Upper Brook Street Masterplan

Environmental Statement Addendum

November 2024

**Williams Motor Co (Holdings)
Limited and Alliance UBS
Limited**

Figure 5.1: B1 Proposed Amendments

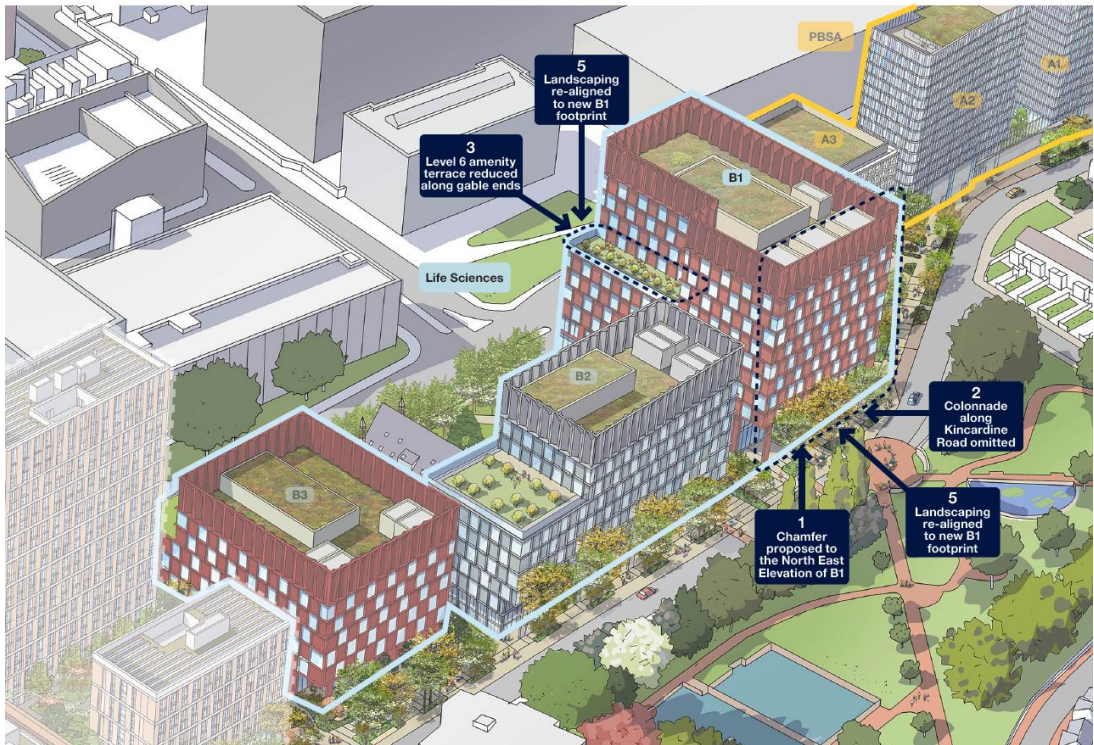
- 5.8 The proposed change seeks to include a chamfer to the Kincardine Road elevation of B1. The chamfer runs consistently down to ground floor level, omitting the need for the colonnade and recessed ground floor that was previously proposed. The chamfer has been designed to maintain the same façade module established in the extant consent, allowing for flexible lab / office space within the building and a high-quality expression that links the masterplan and integrates within the immediate context.

6. New standalone lettable introduced to the ground floor of B1
 7. Removal of B1 basement
- 5.10 Collectively, these design changes result in an increase of 305m² in the total Gross Internal Area.

Figure 5.10: Landscape Changes at Ground Level

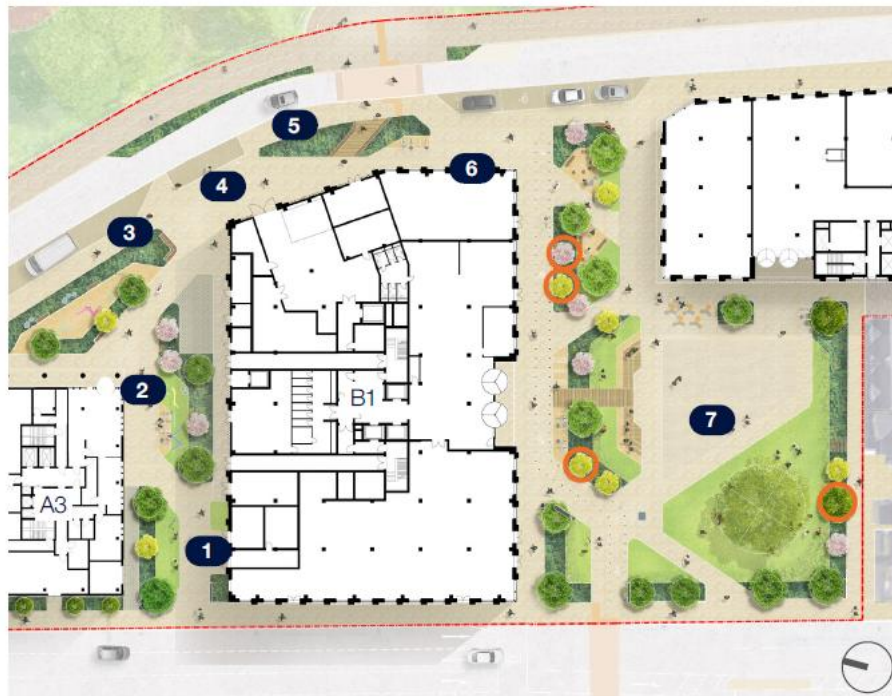
- 5.13 The revised footprint to building B1 has resulted in a narrowing of the public realm between B1 and A3 by just over 2m. Although the functionality and character of the space will remain the same, some areas of green space have marginally

- 5.15 The proposed landscape amendments include the following:
1. Small areas of planting adjacent to B1 changed to respond to new door locations.
 2. Green space arrangement altered to respond to narrowing of space between A3 and B1. Central play path removed and replaced with lawn. Lawn to include informal play features. Seating offer retained.

3. Green space arrangement opposite lay-by slightly updated to accommodate revised service vehicle tracking to B1.
 4. Minor alteration to service vehicle access point off Kincardine Road and turning area adjacent to B1.

6. New clearly defined open space opposite ground floor commercial unit to accommodate potential spill-out.
 7. Four trees relocated into public square as part of general tree redistribution (new location outlined in orange). Displacement caused by utility easement restrictions and consolidation of some areas of green space described above.
